Merton Council Planning Applications Committee 8 December 2022 Supplementary agenda

Planning Applications Committee 08th December 2022 Supplementary Agenda Modifications Sheet.

<u>Item 5 – Broghill House, Queen Alexandras Court, St Mary's Road,</u> <u>Wimbledon SW19 7DE</u>

Item 6 - 30A Ridgway Place, Wimbledon, SW19 4EP

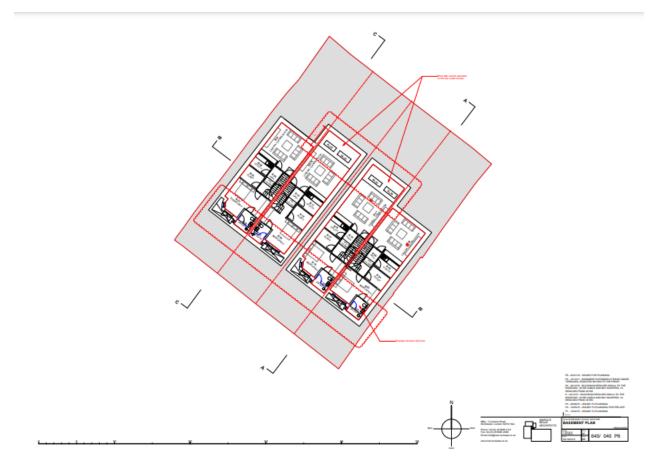
Cllr Aidan Mundy has requested further details of how this application came about.

For further context, please see below the plan of the basement layout that was permitted in 2018 (18/P0253). You will see that basements were permitted for the middle two houses, but not the outer two including the subject property.

Further to the history at paragraph 4.2.2 of my report, I can confirm that the applicant submitted an application earlier this year (22/P1868) for a rear ground floor extension. It came to light when I started reviewing the planning history that the basement on which the extension was to be built did not itself have planning permission. Tim Bryson and I advised the applicant's agent to withdraw the application; gather evidence that the basement had been constructed in compliance with Merton's policies on basement impacts; and resubmit the retrospective application and the application for the extension together.
